Edgemere Subdivision: Planned Unit Development Narrative Updated Per P&Z Comments

April 13, 2026

### **Edgemere Subdivision**

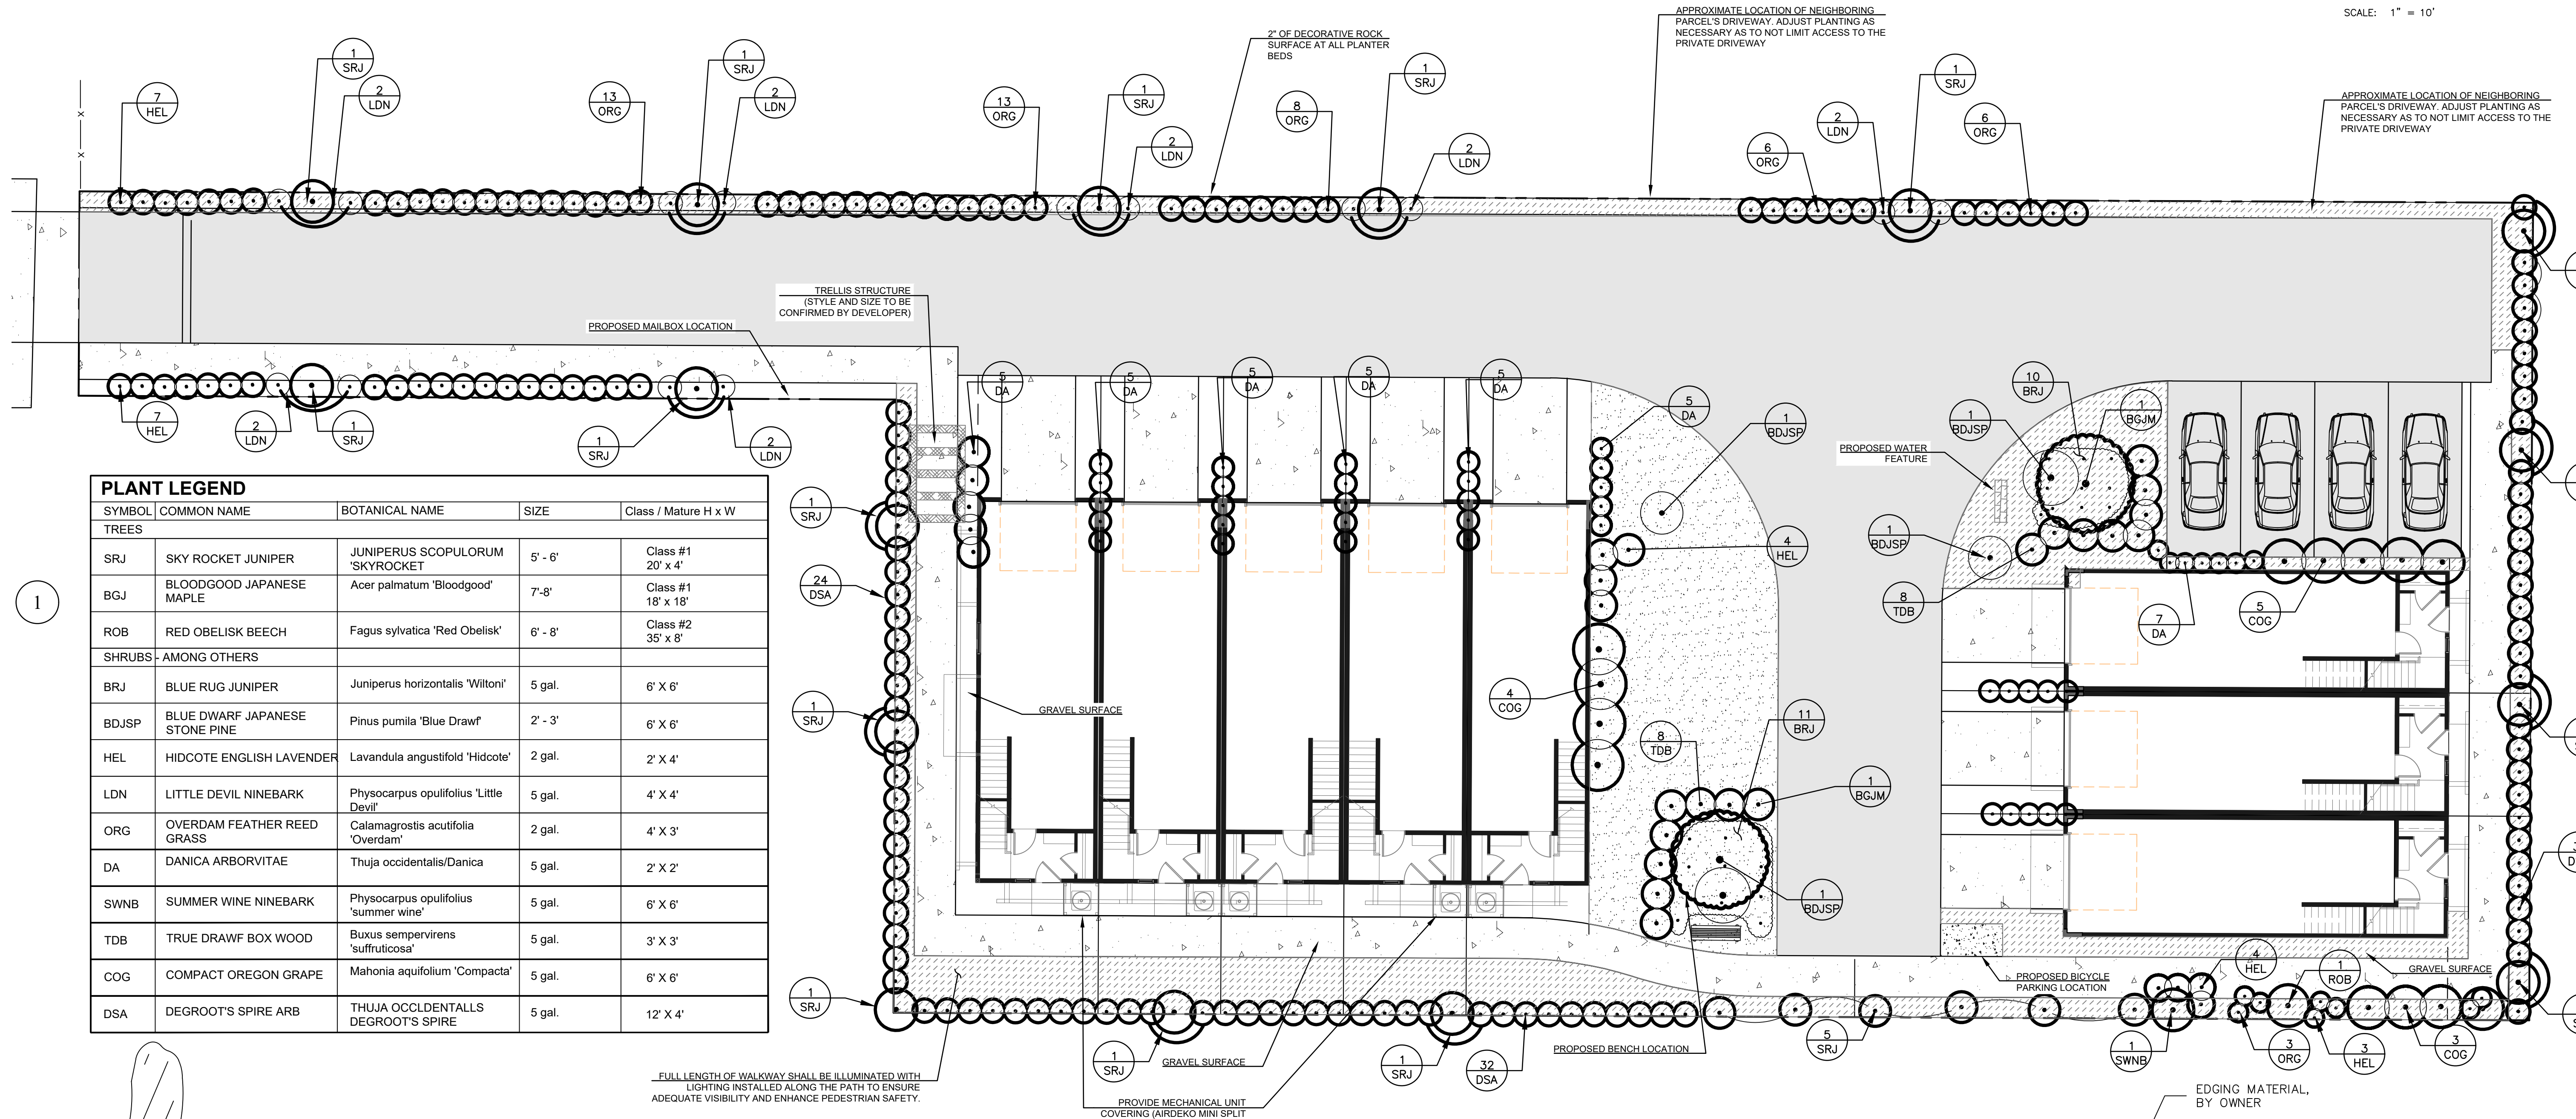
We were proposing buildings that were ≈39' tall to the top of the roof with a 26' wide access road and a 15' setback from the edge of the road to the building as required by the fire code.

However, if we were to keep the buildings >30' tall, is it possible to reduce the fire access road width from 26' down to 20' or reduce the building setbacks from 15' down to 5' (or reduce the width of the road AND the setback) if we propose fire sprinklers in the buildings? The goal would be to move the buildings closer to the road so that we could add more open space along the pathway of the site. If you've seen anything like this in the past or have any other suggestions on how we might work around this please let me know.

We will still need the 15' driveways because we are still going to bring our ladder truck down this drive. We just won't have room to move any fire engines by the truck due to the decrease in width to 20'.

We can allow for the road width to be narrowed to 20' from 26' with the addition of fire sprinklers in the units. This approval is based on the floor plans that are attached. Any changes in building height or stories will require a review by me for approval.

## OPEN SPACE (LANDSCAPING AREA) EXHIBIT

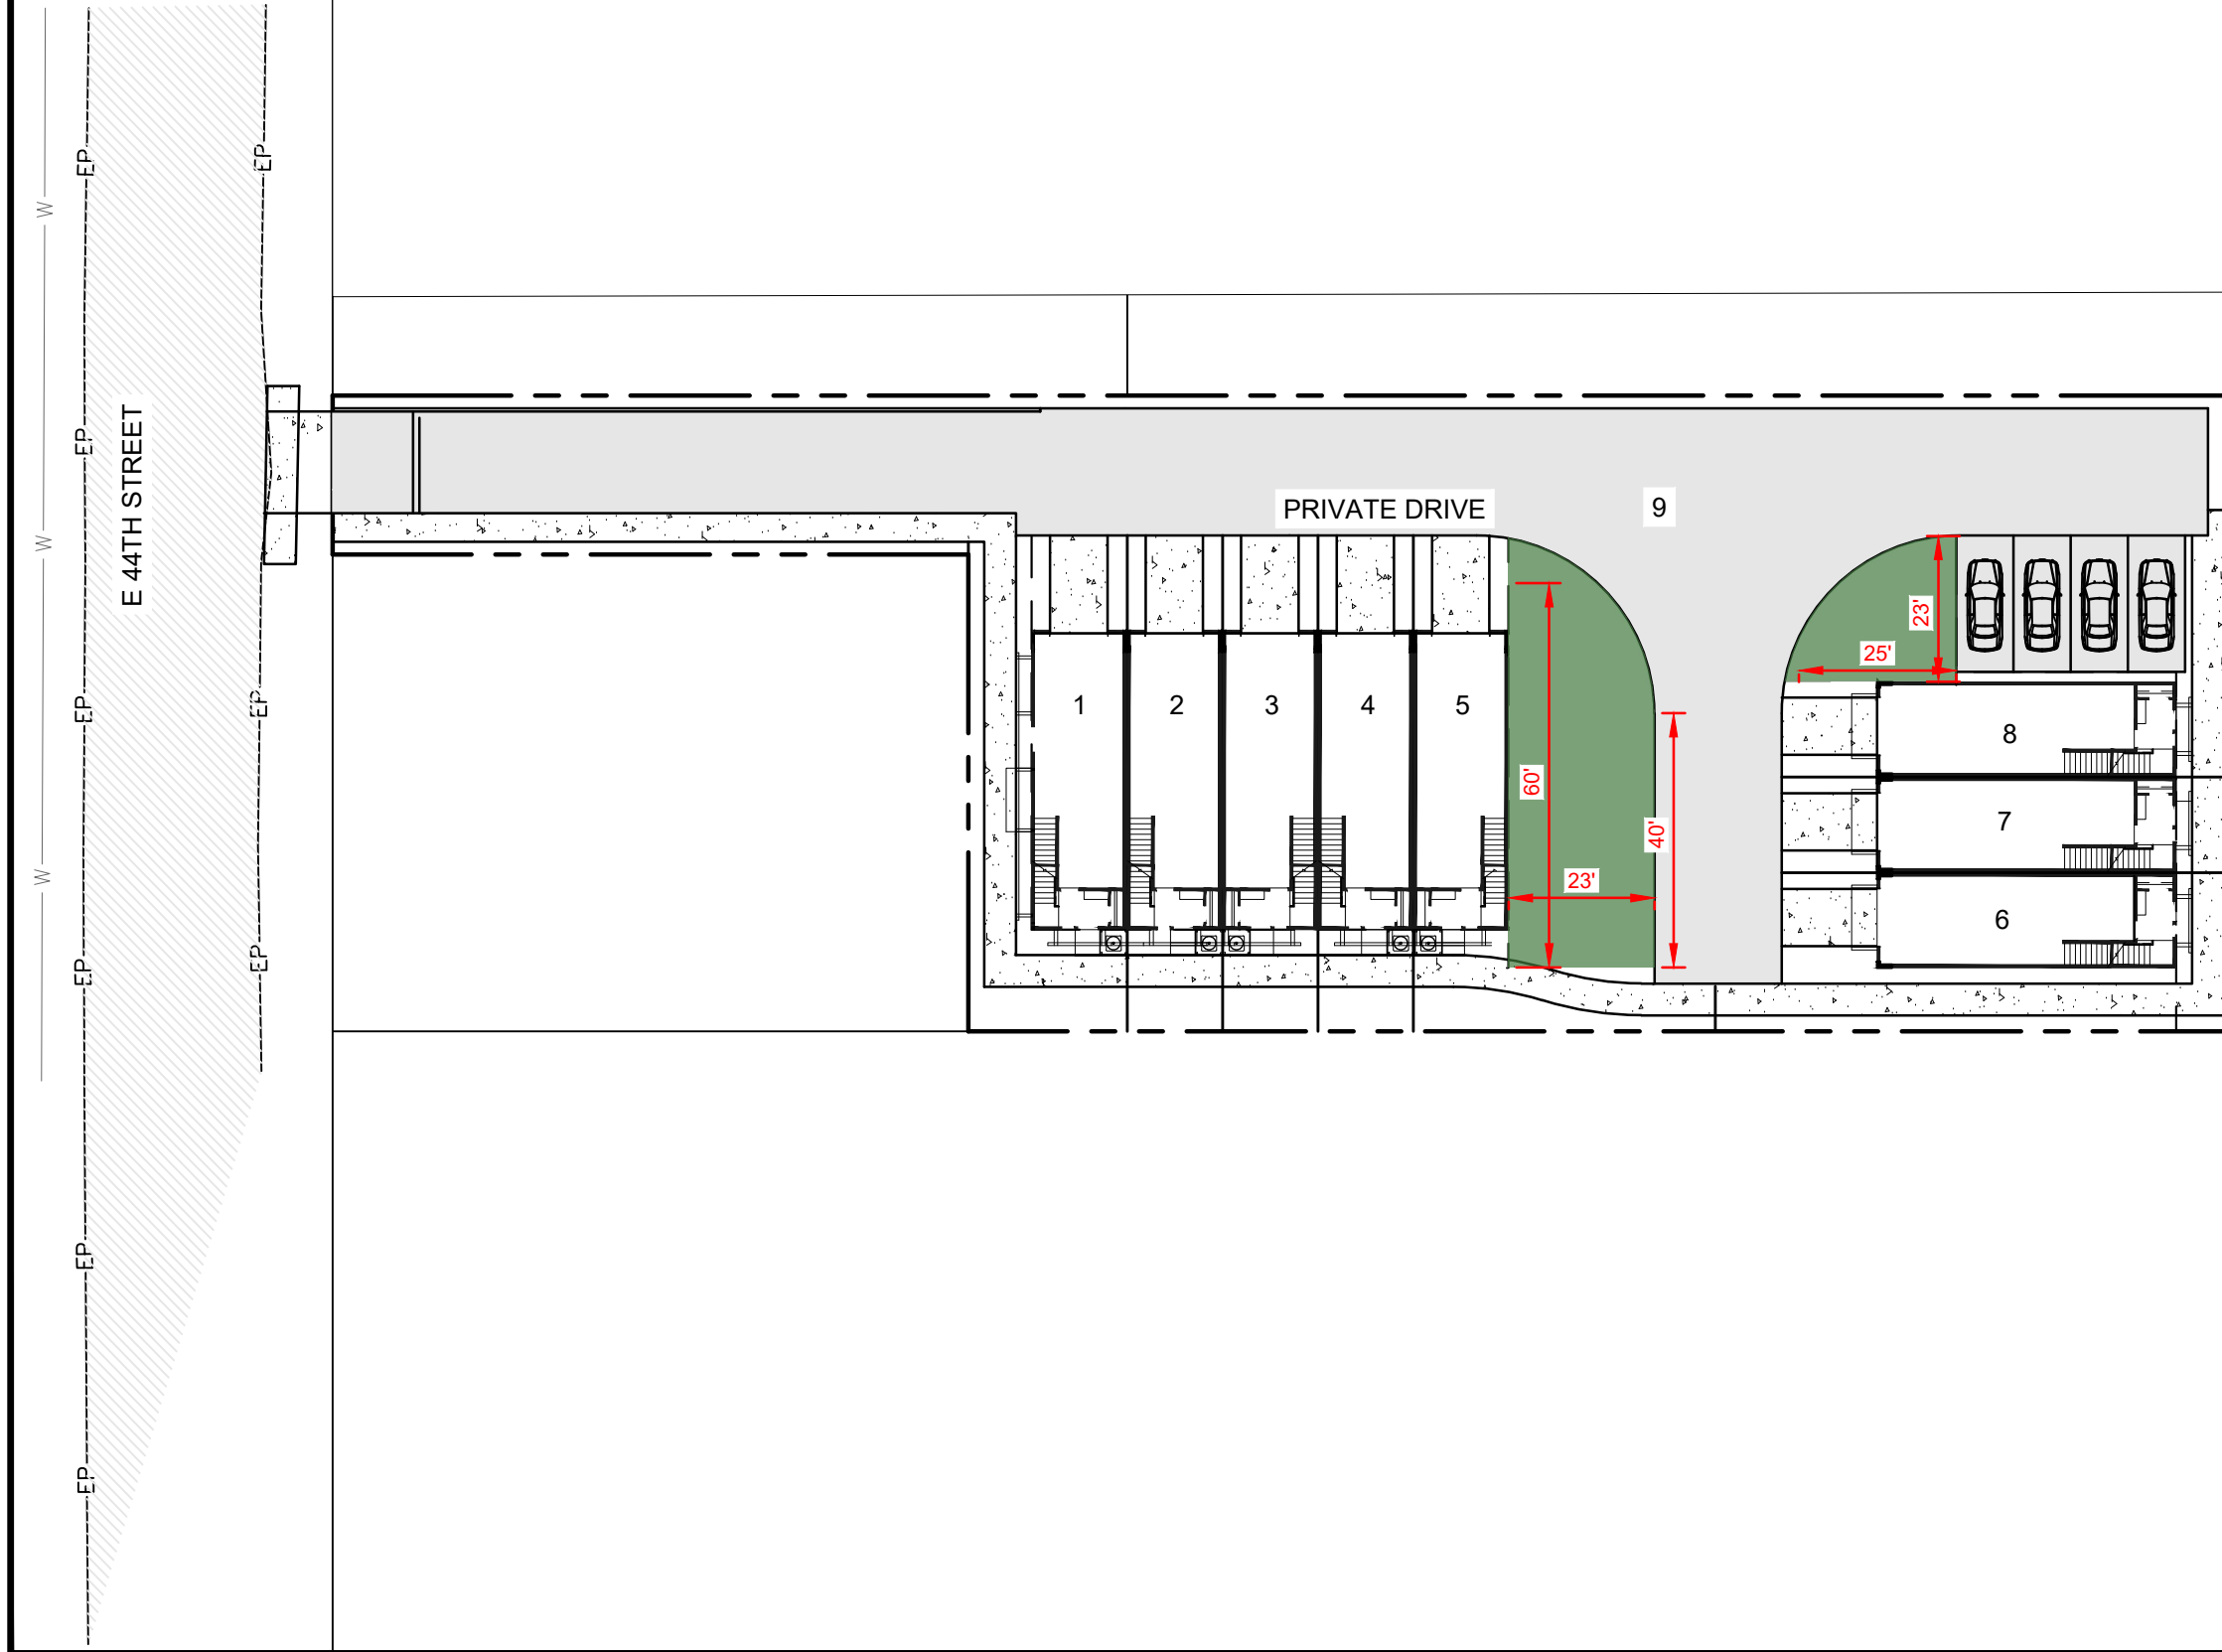
Based on coordination with City staff, the revised plan provides two primary common open space areas measuring approximately 1,955 square feet combined. While this remains slightly below the ten percent (10%) threshold identified in code, the developer has focused on increasing the width and functionality of these spaces so that they can serve as usable areas for residents.

## PARKING EXHIBIT

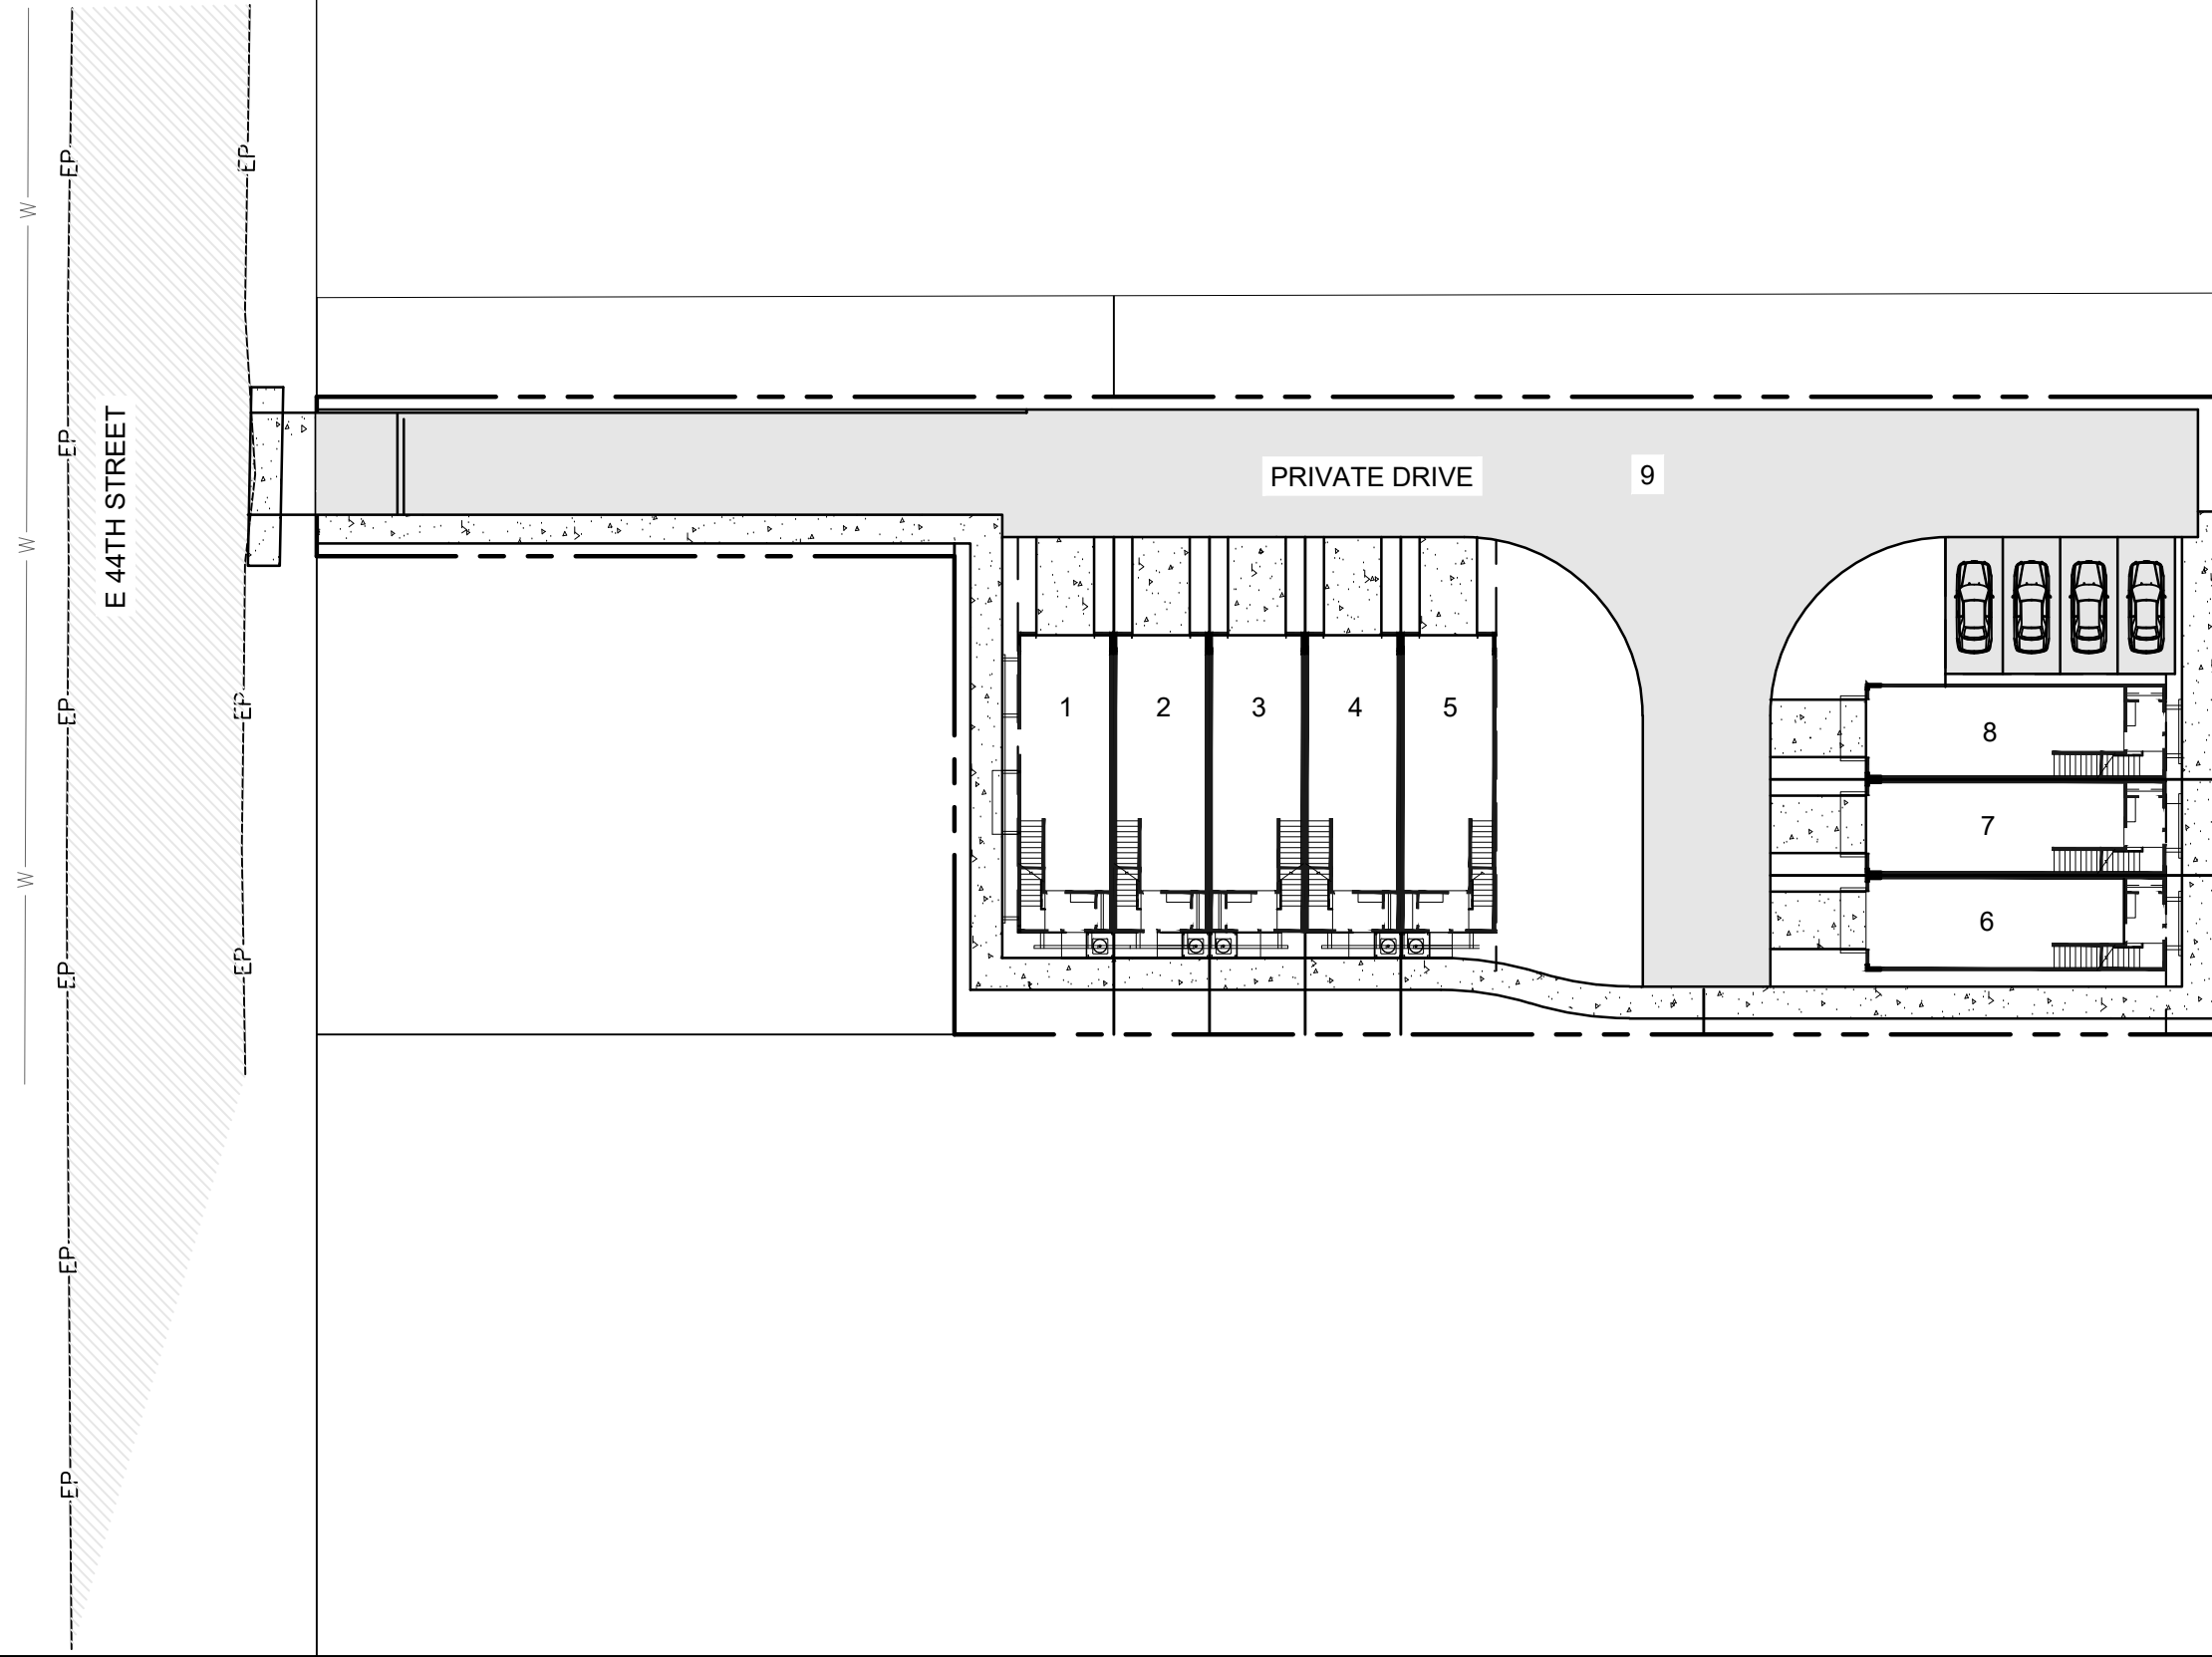
Each unit now includes a garage that is forty feet (40') in depth, allowing for two parking stalls in tandem, each meeting the City's dimensional standards. This change removes the need for the previously requested garage dimensional deviation.

In addition, four (4) full-size guest parking stalls have been added to the site. These stalls meet the City's minimum dimensional requirements and were included specifically to address concerns regarding guest parking availability.
